CONTRACT CHANGE ORDER NO. _____
SHEET OF

DETAILS
SAS SUPERSTRUCTURE ROADWAY EASTBOUND
CONDUIT LOCATIONS
SCALE AS NOTED

E-162

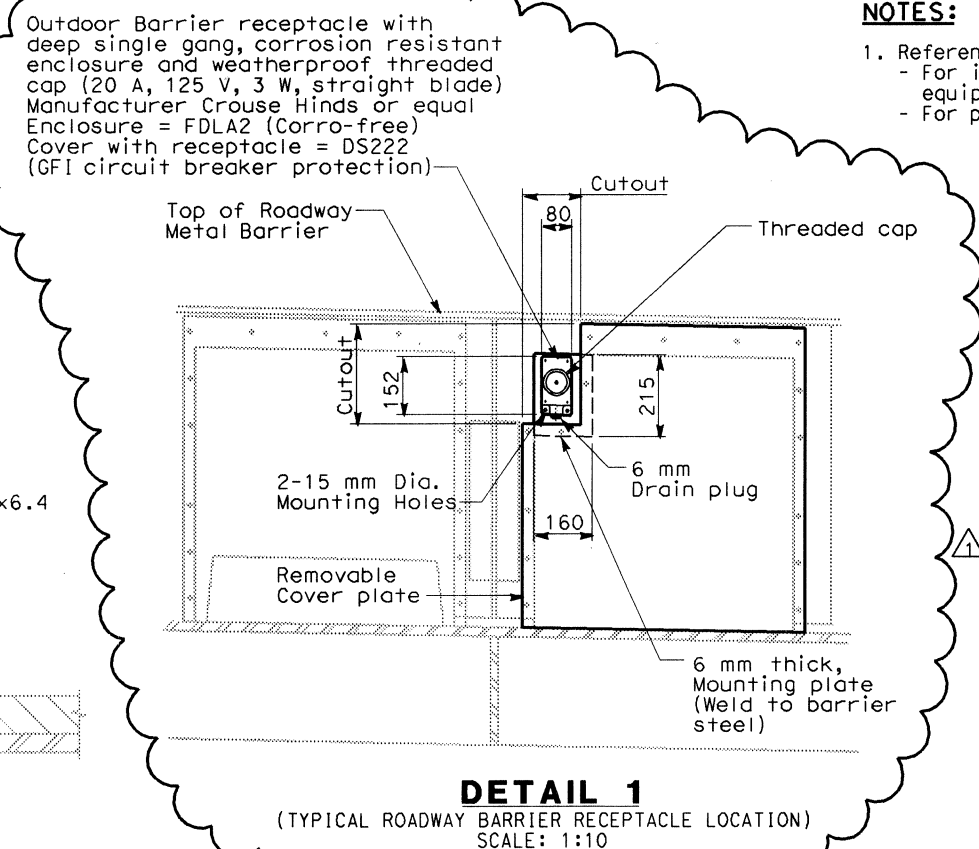
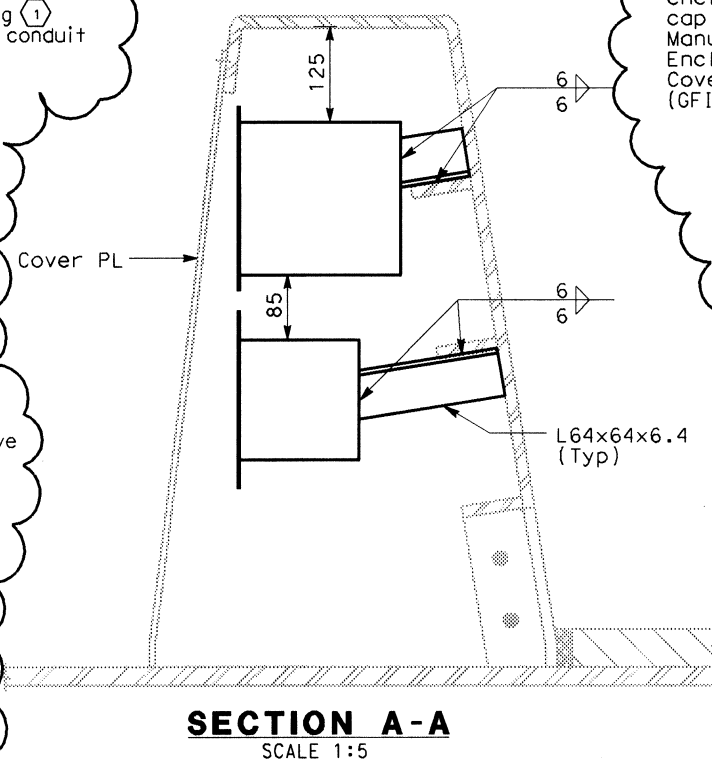
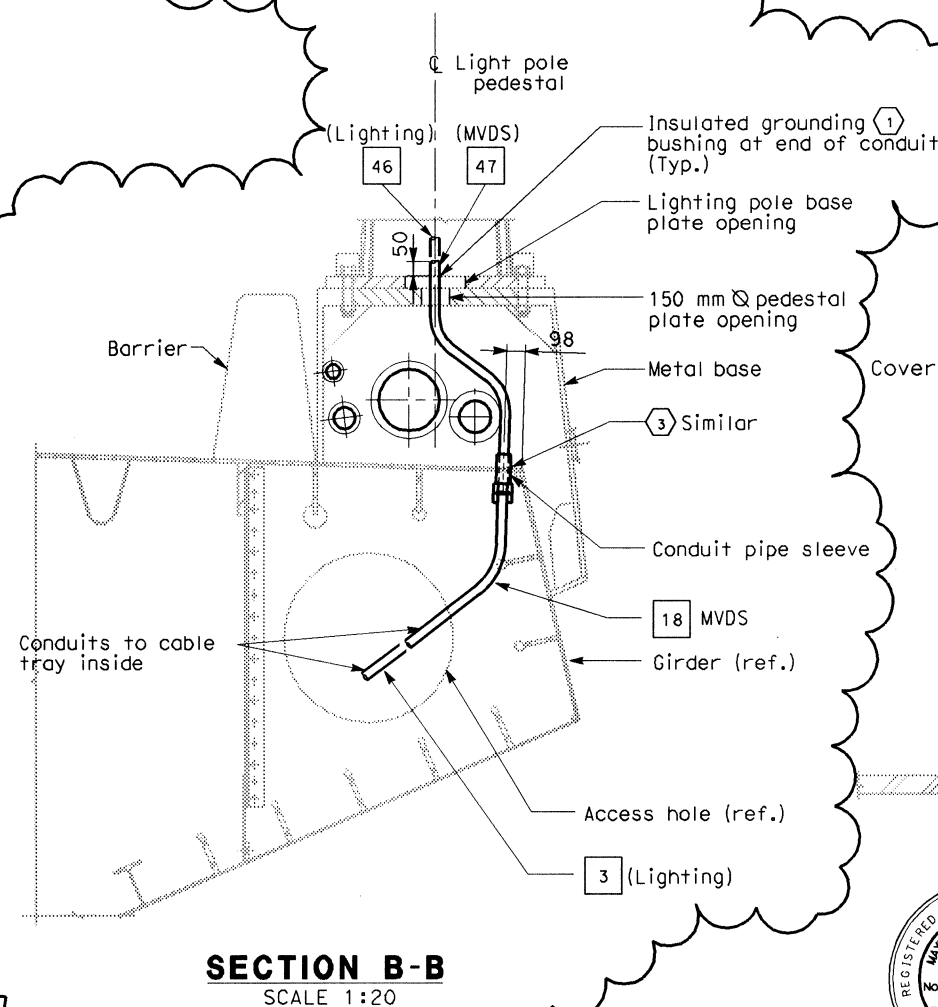
-
- 1 Bond grounding bushing to ground lug of lighting pole with #6 bare copper wire.
- 2 Deleted
- 3 Conduit penetration thru girder plate and lighting pole metal base, see Utility Detail No. 1 of Superstructure and Tower Drawings. To prevent moisture from passing inside the sleeve, the Contractor shall install sealant between the sleeve and conduit.
